From: <Joseph_Hegner@dom.com>
To: <bxs2@nrc.gov>
Date: Tue, Aug 2, 2005 4:40 PM
Subject: Follow-up from July 26, 2005 Conference Call

Responses to NRC Questions of July 26, 2005 Conference Call

On July 26, 2005, a conference call was held between the NRC Staff and Dominion to discuss Dominion's July 25, 2005 letter, Serial No. 05-457 (Reference 1). During the conference call, the NRC asked several questions on the site-specific analysis that was performed to confirm the appropriateness of the V/H ratios used in the ESP Site Safety Analysis Report (SSAR) to establish the vertical safe shutdown earthquake (SSE) spectrum for the Zone III-IV hypothetical rock outcrop control point. Responses to the NRC's questions are provided on the following pages.

Figure 1. Poisson's ratio models with upper and lower bound constraints for Model 2.

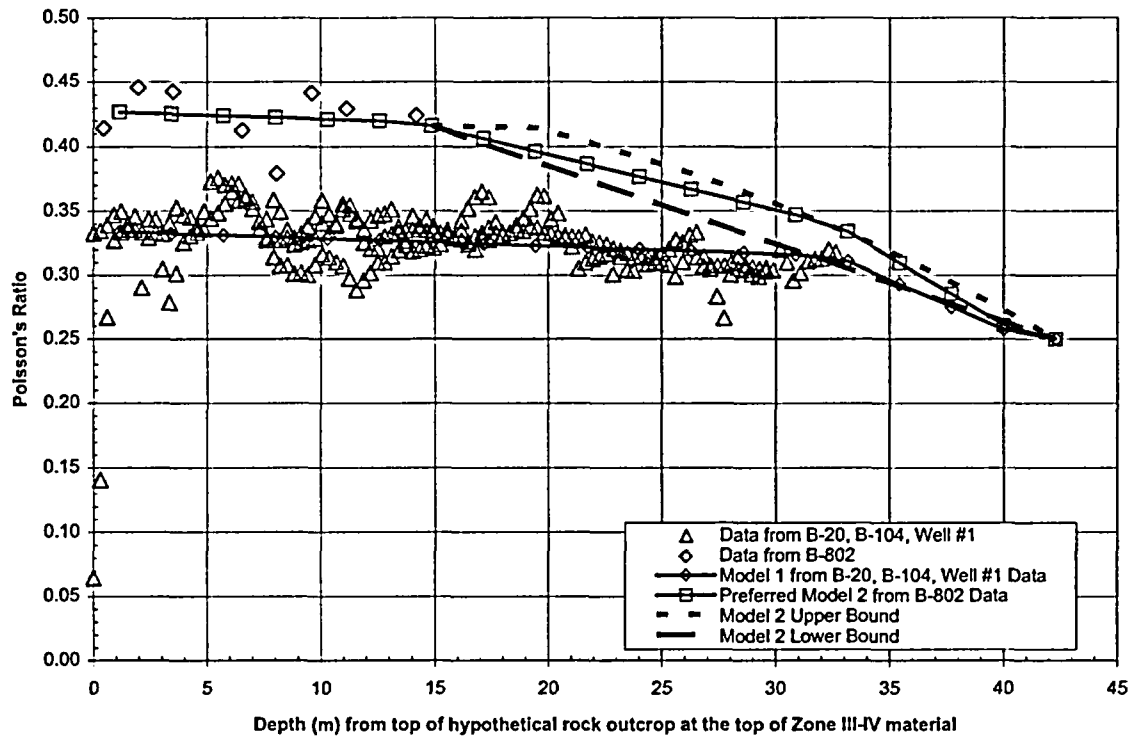
How were Poisson's ratios for Model 2 developed for depths greater than 15m?

Model 2 comprises three linear segments. The first segment [from 0 to ~15m] is the result of a least-squares fit to the available Poisson's ratio data from boring B-802. No S-wave data are available for this boring at greater depths. The end of the deepest [third] segment is constrained to have a Poisson's ratio of 0.25, appropriate for rock at the top of the Mid-Continent crust [EPRI (1993), Reference 2].

The second and third segments of Model 2 are defined to give a simple Poisson's ratio model bounded by two constraints: 1) the model should not cross the Model 1 representation of Poisson's ratio [as a simple two-segment model would], and 2) the corresponding P-wave velocity should not significantly exceed a value of 4,900 m/sec [the P-wave velocity of the rock at the top of the Mid-Continent crust] for depths shallower than 41.0 meters.

If Model 2 had been defined by a single straight line segment from the end of the fit to available data at 15m to the Poisson's ratio value of 0.25 at 41m depth this model would have intersected, and at places, dropped below Model 1. Defined in this manner, Models 1 and 2 would have differed negligibly from depths of ~30m to 41m. Because it was of interest to consider the full range of epistemic uncertainty in the development of the V/H ratios, this convergence of Models 1 and 2 was assessed to be undesirable, establishing a lower bound for the Poisson's ratios of Model 2.

An upper bound to Poisson's ratio Model 2 was defined by the values of Poisson's ratio resulting from fixing the P-wave velocity to have a constant value of 4,900 m/s near the end of the B-802 data at ~15m to the depth of 41m. A

shallower slope model of Poisson's ratio would then imply P-wave velocities greater within the rock column than at its bottom.

Figure 1 shows Model 2 Poisson's ratios and the upper and lower bounding constraints specified.

Figure 2. Preferred V/H mean and fractiles ratios, using weights of 0.25 and 0.75 for Poisson's ratio Models 1 and 2.

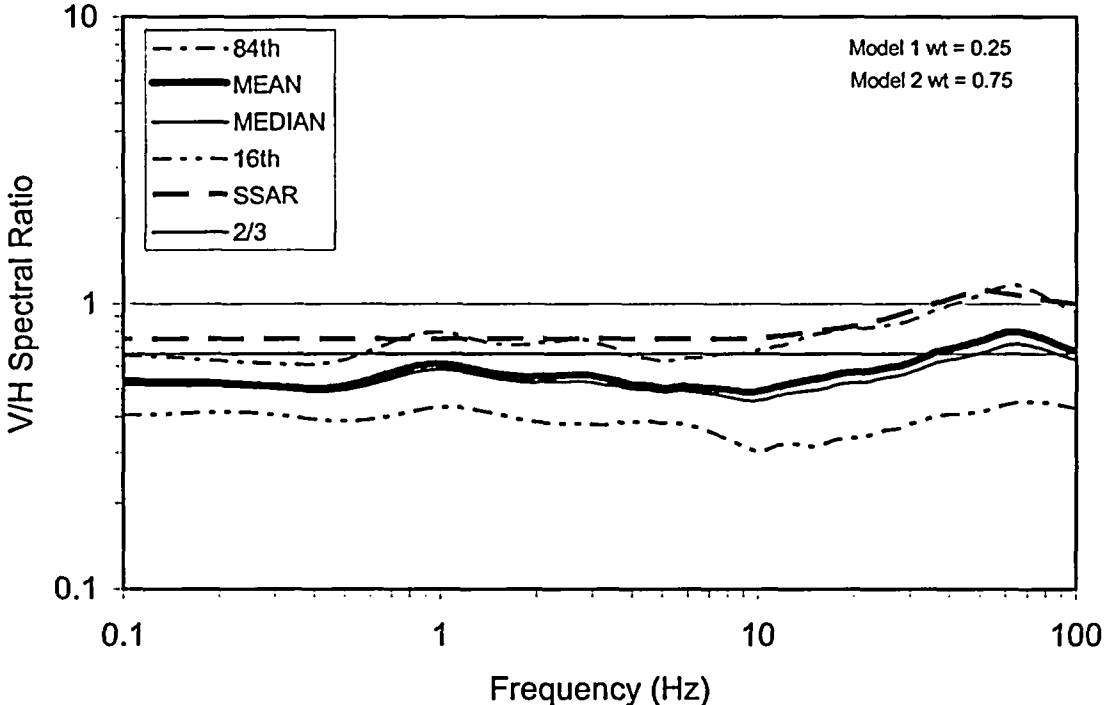
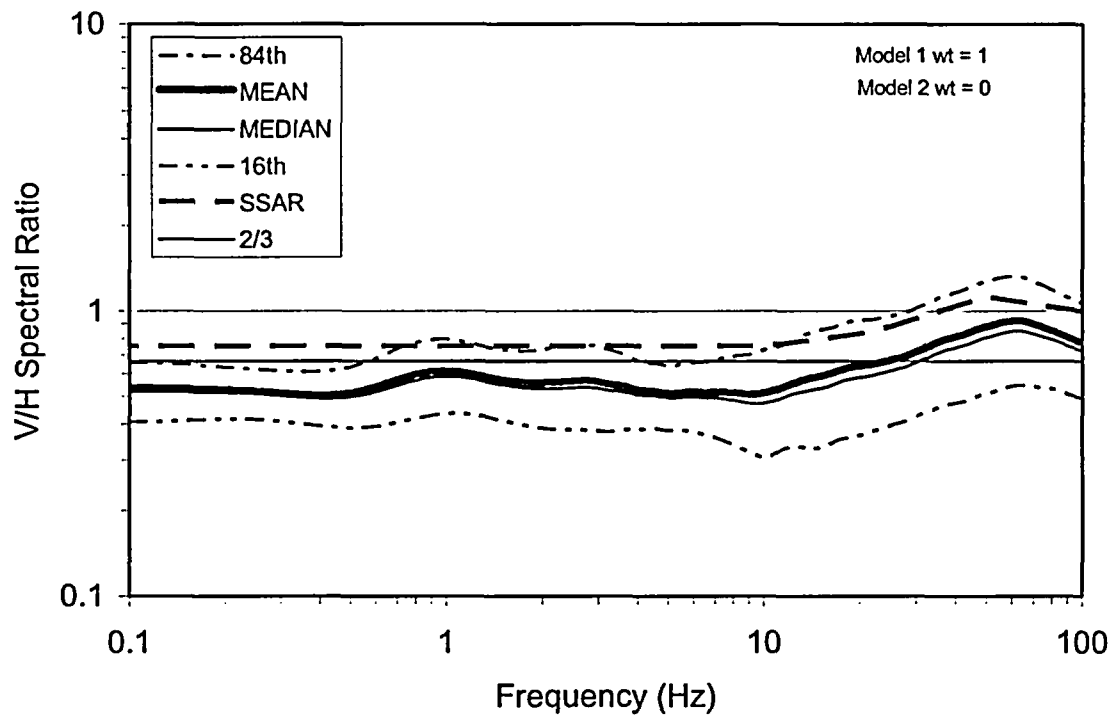
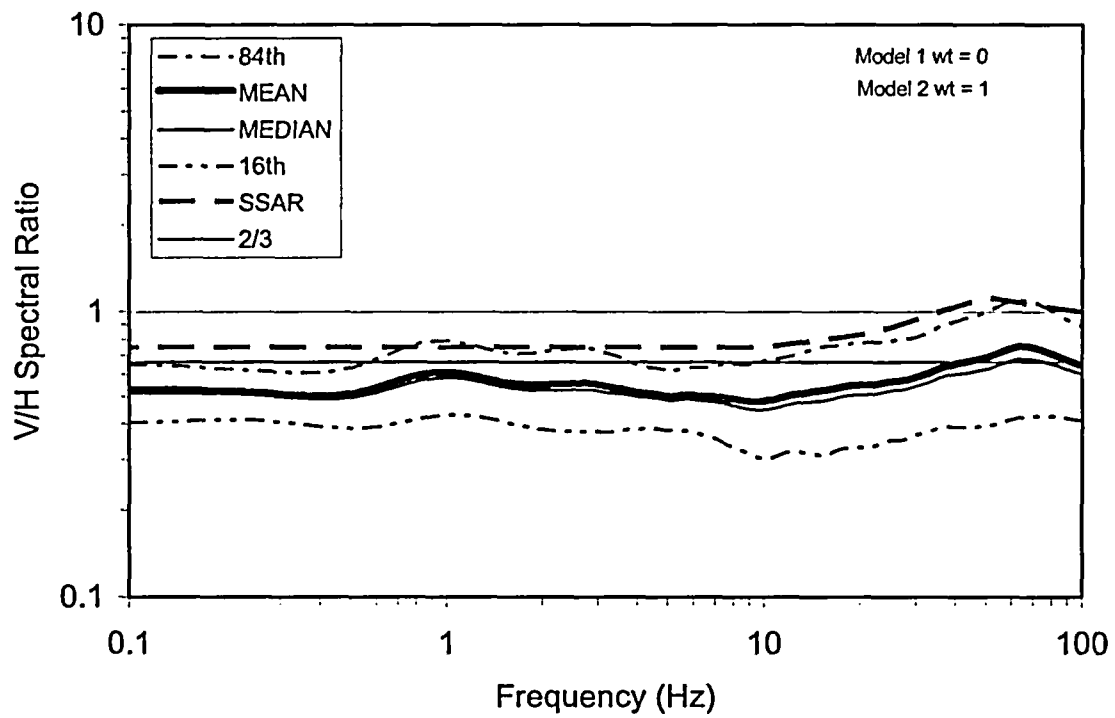
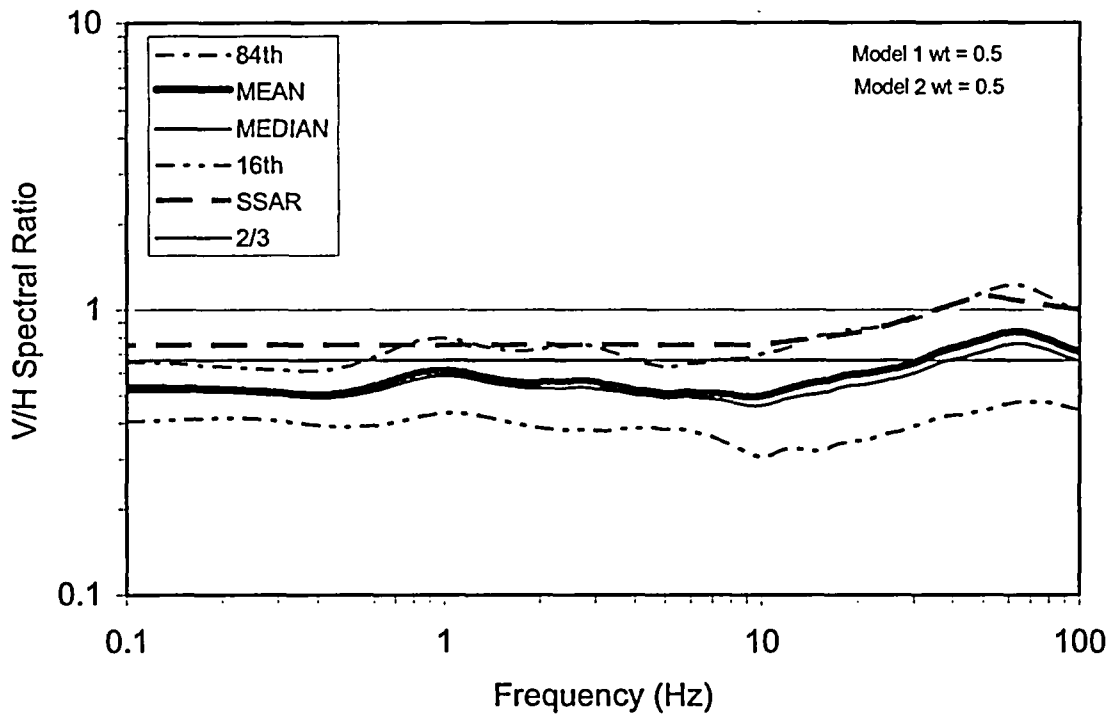
What are the effects on the resultant V/H ratios of considering different weights between Model 1 and Model 2?

Figure 2 shows the resulting V/H ratios for the mean and various fractile results where the weights of 0.25 and 0.75 have been considered for P-wave Models 1 and 2, respectively. A graphical measure of the sensitivity of V/H ratios to the weights assigned to Poisson's ratio Models 1 and 2 is provided in several additional plots. In Figure 3, Model 1 has been given a weight of 1.0 and Model 2 a weight of 0.0, putting complete confidence in the older, original site geotechnical investigation data. In Figure 4, Model 2 has been given a weight of 1.0 and Model 1 a weight of 0.0, putting complete confidence in the recent ESP subsurface investigation data. Finally, both models have been given equal weight in Figure 5.

While the 0.25 Model 1 and 0.75 Model 2 weight distribution is preferred, the effect on V/H ratios is modest over the entire range of possibility and does not affect the fundamental conclusion that the V/H ratios given in NUREG/CR-6728 for hard rock and used in SSAR Table 2.5-27A for development of the vertical SSE spectrum are appropriate.
